SERVICE BULLETIN

SB-42-016-2013 Elevator Bearing Block

Inspection of elevator bearing block and exchange of the Polyamide distances.

All IKARUS C42 and C42 B to serial number 1301-7234

Image 1 previous version

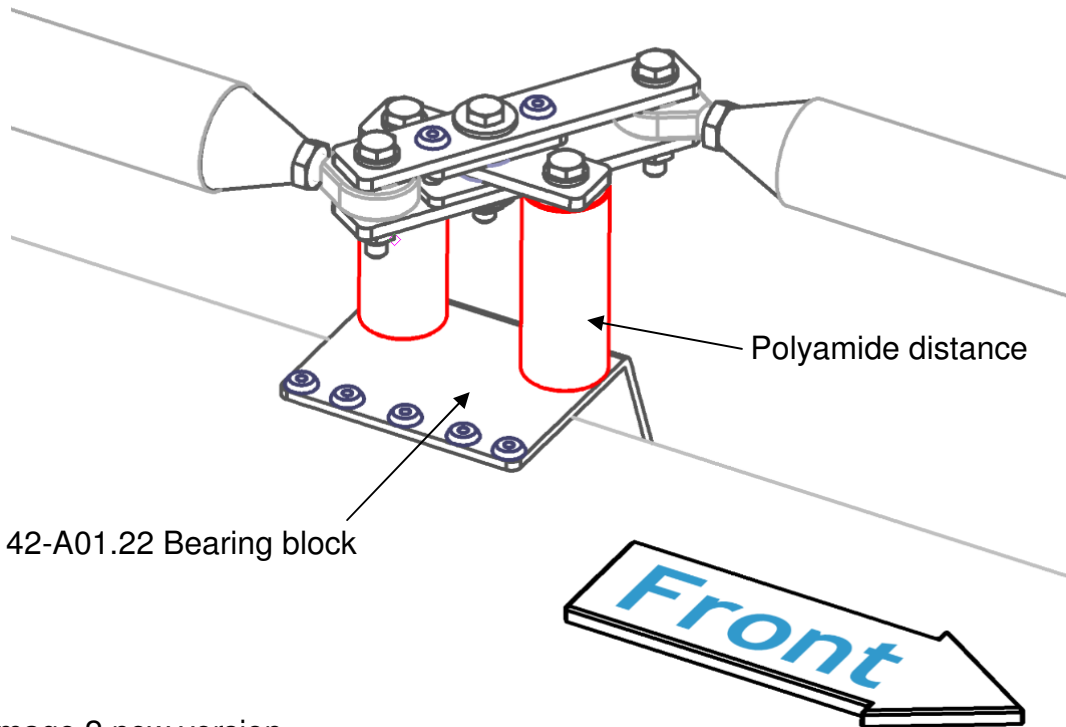
By overloading on the ground (support on stick or elevator) or by clearance in the elevator linkage, the Polyamide distances can cause cracks in the bearing block.

Inspection of elevator linkage on stiffness and straightness of the Polyamide distances. Visual inspection of the elevator bearing block for cracks in the area of the bend. When in doubt, remove the screws securing the Polyamide distances for free accessibility of the bearing block.

Recommended: replacement of Polyamide distances by 42-A15.15A "stop distance elevator balance "(page 3: images 1 and 2)
When cracks are found in the bearing block: exchange the elevator bearing block.
For this purpose, knock out the steel cores of the rivets into the main tube with a punch and drill out the rivets.
The bearing block must be replaced with part 42-A01.22 "bearing block elevator pushrod" and riveted to the main tube.
For this purpose, the included high-strength blind rivets are to be used.
For assembling, new self-locking nuts must be used.
Then the elevator deflections are to be checked upward and downward.
If necessary, the elevator pushrods shall be re-adjusted and secured.
